Informal document **GRE-68-20**
(68th GRE, 15-18 October 2012,
agenda item 4(b))

Comments on GRE/2012/27(Lighting & Signalling WG)

Headlamp Initial Aiming

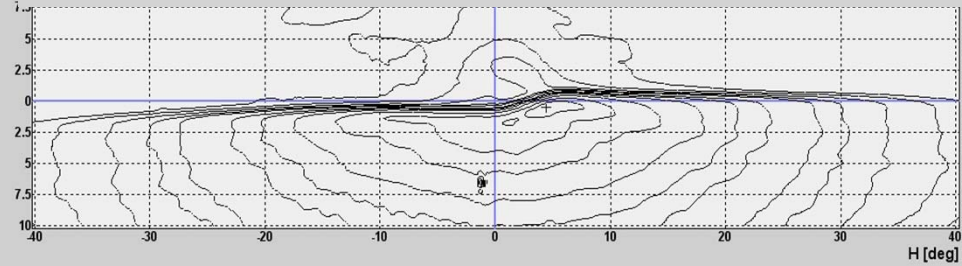
60m
forward
Visibility

Low gradient through the cutoff = less glare sensitivity to initial aiming tolerances

- Both lamps have a theoretical range of 75m
 - Sample 11 has TC4-45 visibility range of 60m
 - Sample 5 has TC4-45 visibility range of 85m
- **Conclusion: theoretical range is a poor measure of real-world visibility**

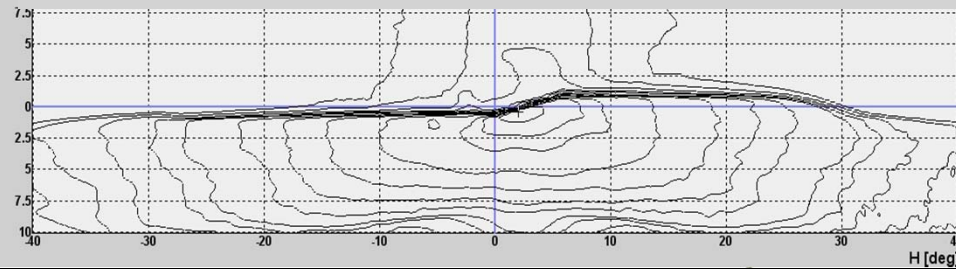
85m
forward
Visibility

High gradient through the cutoff = more glare sensitivity to initial aiming tolerances

Tolerance with load levelling

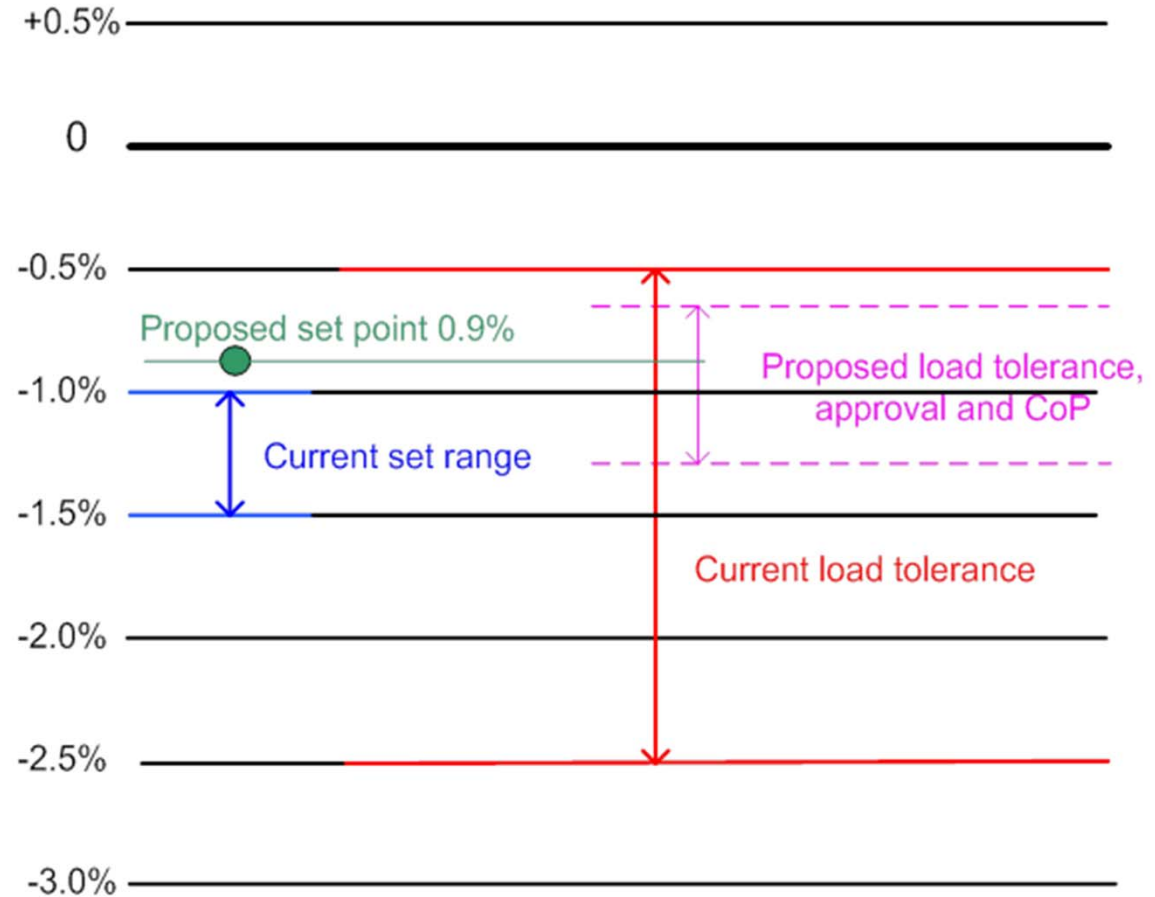
Example for
650mm high
passenger car
headlamp

- To consistently meet CoP requirements, initial aim and levelling system need to be repeatable with a standard deviation of better than 0.1%.
Repeatability of suspension system alone is not this good.
